PCI-SIG ENGINEERING CHANGE NOTICE

TITLE:	Lightweight Notification (LN) Protocol
DATE:	Introduced: Jan 27, 2009; Last Updated Oct 2, 2011 Protocol Workgroup Final Approval: October 6, 2011
AFFECTED DOCUMENT:	PCI Express Base Specification version 3.0
SPONSOR:	Hewlett-Packard, Advanced Micro Devices

Figure 2-x: LN Message

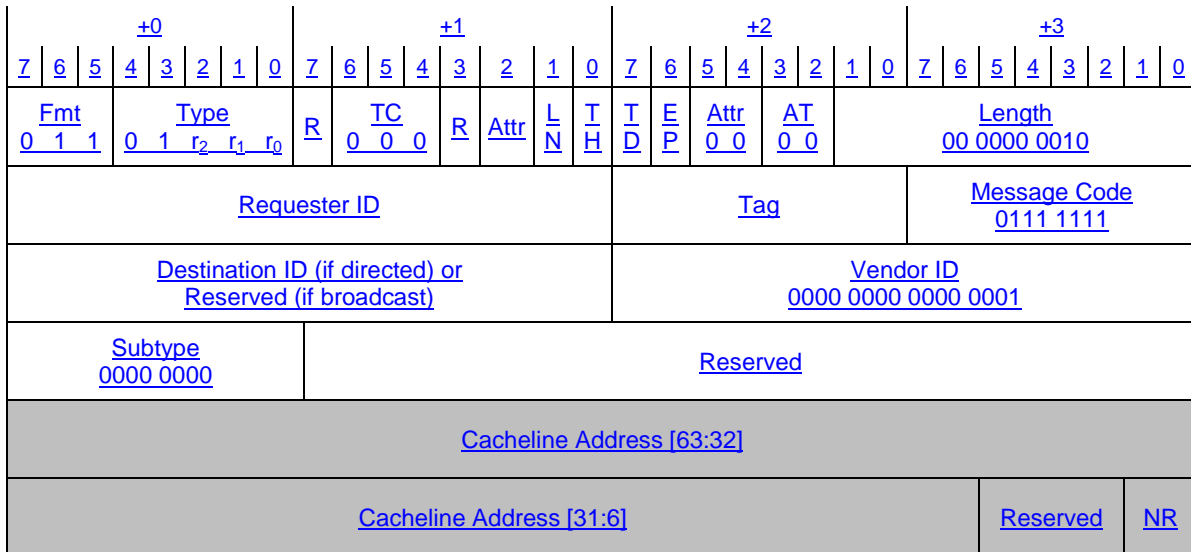
- Table 2-x and Figure 2-x define the LN Messages.
- Each Message must include a 2-DWORD data payload.
- The Fmt field must be 011b (4 DW Header, with data).
- The TLP Type must be MsgD.
- The Length field must be 2.
- The TC[2:0] field must be 000b.
- Attr[2], the ID-Based Ordering (IDO) bit, is not Reserved.
- Attr[1], the Relaxed Ordering (RO) bit, is not Reserved.
- Attr[0], the No Snoop bit, is Reserved.
- Note: as with all Messages, the LN bit is Reserved. In contrast, the LN bit must be Set for LN Reads, LN Writes, and LN Completions.
- The Tag field is Reserved.
- If the LN Message is the broadcast version, the Destination ID field is Reserved.
- The Subtype field must be 00h.
- If the cacheline size in effect for the system is 128 bytes, bit 6 in the Cacheline Address must be Clear. For an LNR receiving an LN Message, if the LNR CLS bit in the LNR

The format the LN Message is shown in Figure 2-x below.

Figure 6-x: Sample System Block Diagram

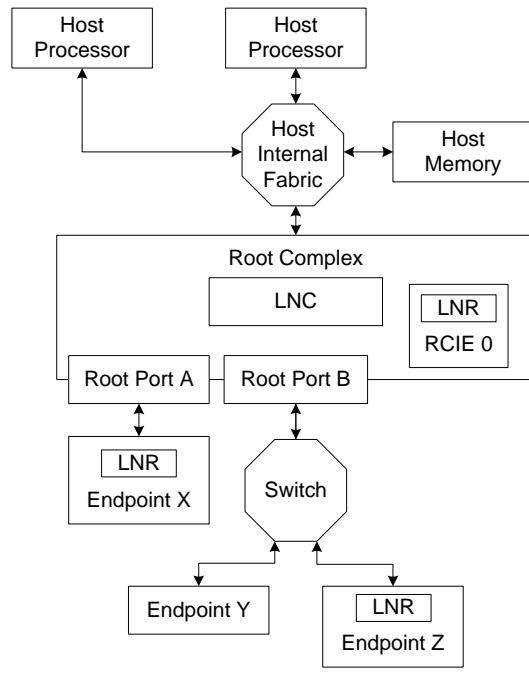
A typical system consists of host processors, host memory, a host internal fabric, Root Ports, Switches, and Endpoints. Figure 6-x below illustrates a simplified view of the elements and how they are interconnected to provide a context for describing how LN protocol operates.

In the figure above, Endpoint X, Endpoint Z, and RCIE 0 each contain an LNR. The Root Complex contains an LNC.

Figure 6-x: LN Protocol Basic Operation

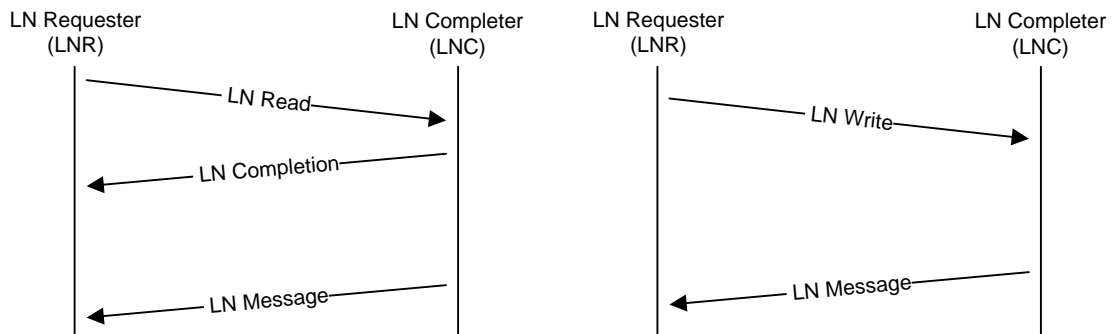
LN protocol operation with a single LNR is shown in the diagram above. For the case of reads, as shown on the left: (1) an LNR requests a copy of a line from host memory using an LN Read; (2) the LNC returns the line in an LN Completion and records that the LNR has registered the line; and (3) the LNC later notifies the LNR using an LN Message when the registered line has been updated. For the case of writes, as shown on the right: (1) an LNR writes to a line to host memory using an LN Write; (2) the LNC records that the LNR has registered the line; and (3) the LNC later notifies the LNR using an LN Message when the registered line has been updated.

Figure 7-25: Device Capabilities 2 Register

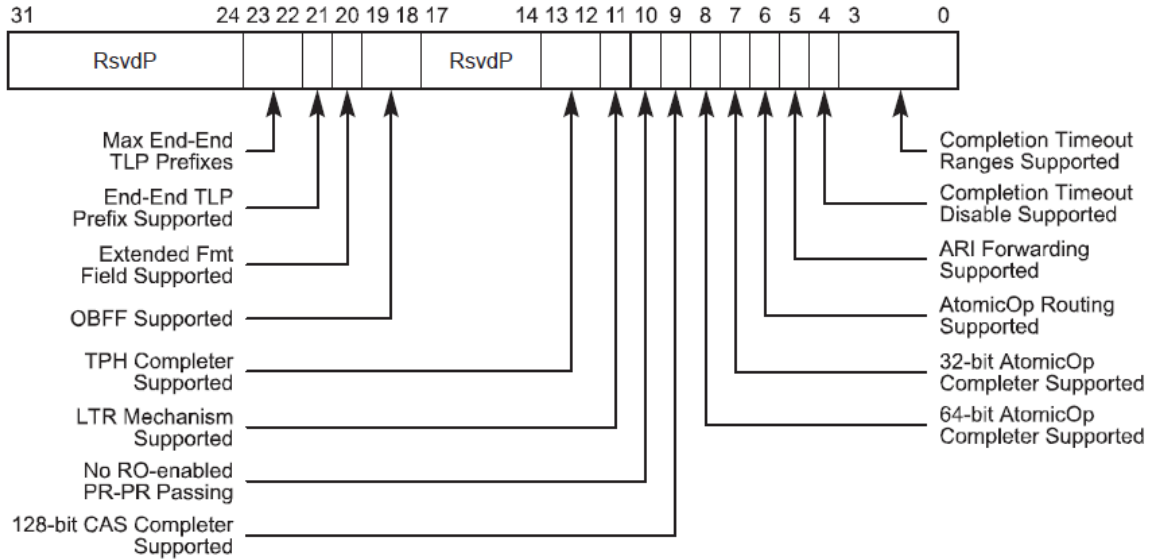
Note to Editor: modify Figure 7-25 to reflect the new field defined below:

Bit Location	Register Description	Attributes
...
15:14	<p>LN System CLS – Applicable only to Root Ports and RCRBs; must be 00b for all other Function types. This field indicates if the Root Port or RCRB supports LN protocol as an LN Completer, and if so, what cacheline size is in effect.</p> <p>Encodings are:</p> <ul style="list-style-type: none"> 00b LN Completer either not supported or not in effect 01b LN Completer with 64-byte cachelines in effect 10b LN Completer with 128-byte cachelines in effect 11b Reserved 	HwInit
